# Service Bulletin

Bulletin No.: PIC5922

**Subject:** Revised Front License Plate Bracket Installation Instructions

**Models:** 2014 Cadillac CTS Sedan  
with Front License Plate Mounting Package (RPO VK3)

Revised License Plate Bracket Installation Instructions

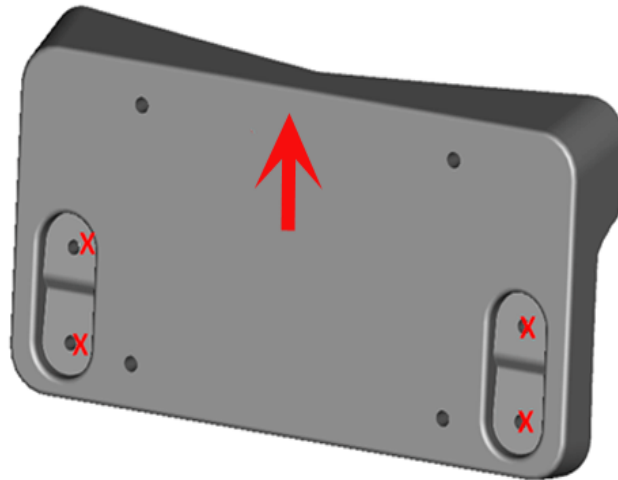
The installation of the front license plate bracket (if equipped) has been revised for better retention. Do NOT use the rivets included in the trunk bag for installing the Front License Plate Mounting Package (RPO VK3). If bolts and u-nuts are included in the trunk (small package with instruction sheet), use those to install the bracket following the instructions below. If bolts and u-nuts are not in the trunk, order four (4) bolts and four (4) u-nuts to install the front bracket. Reference Parts Information section below.

3631355

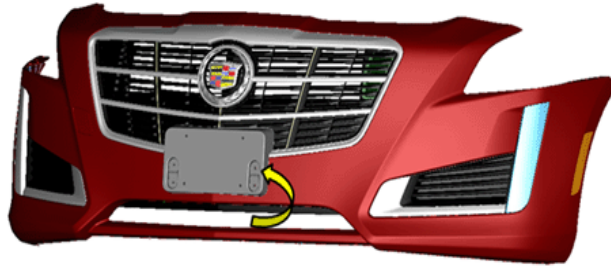
1. Drill 5.0 mm holes in all 4 location holes in bracket marked "X"
